QUINNELLY SUBDIVISION

The purpose of this application is to create a one-lot subdivision from a metes and bounds parcel.

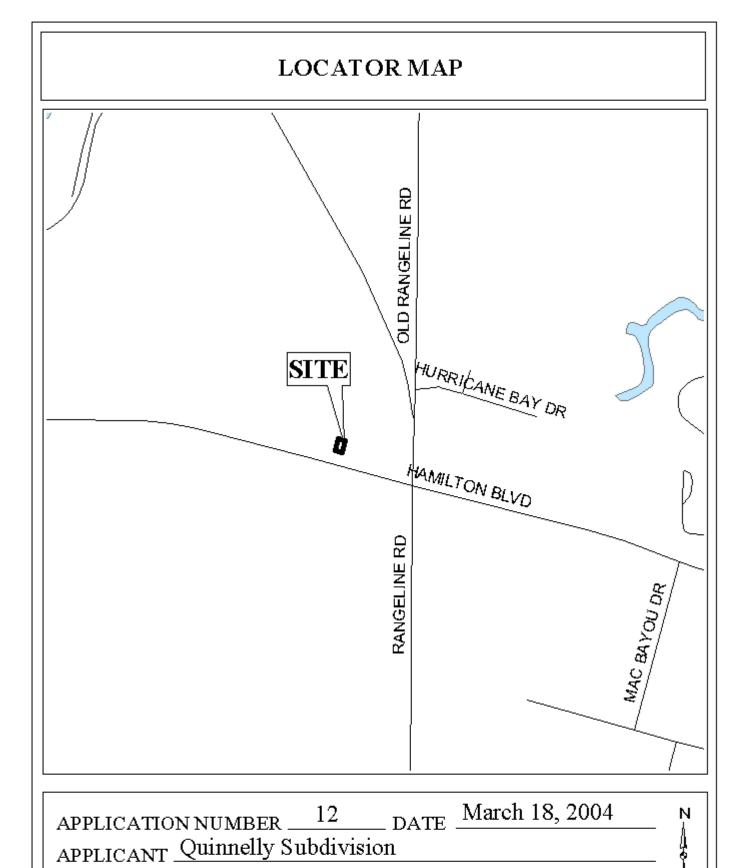
Hamilton Boulevard, which has an existing right-of-way that varies, is shown as a major street on the Major Street Plan, and as such requires a 100-foot right-of-way; therefore, dedication of any necessary right-of-way, to provide 50-feet from the centerline of Hamilton Boulevard, should be required. Additionally, as a means of access management, a note should be placed on the final plat stating that the site is limited to one curb cut to Hamilton Boulevard, with the size, location and design to be approved by County Engineering, should be required.

This site is located in the County, thus a note should be placed on the final plat stating that any lots which are developed commercially and adjoin residentially developed property must provide a buffer, in compliance with Section V.A.7. of the Subdivision Regulations.

The 25-foot minimum building setback line is not shown but would be required on the final plat.

The plat meets the minimum requirements of the Subdivision Regulations and is recommended for Tentative Approval subject to the following conditions: 1) the dedication of sufficient right-of-way to provide 50' from the centerline; 2) the placement of a note on the final plat stating that the site is limited to one curb cut to Hamilton Boulevard, with the size, location and design to be approved by County Engineering; 3) the placement of a note on the final plat stating that any lots which are developed commercially and adjoin residentially developed property must provide a buffer, in compliance with Section V.A.7. of the Subdivision and 4) the placement of the 25-foot minimum setback line on the final plat.
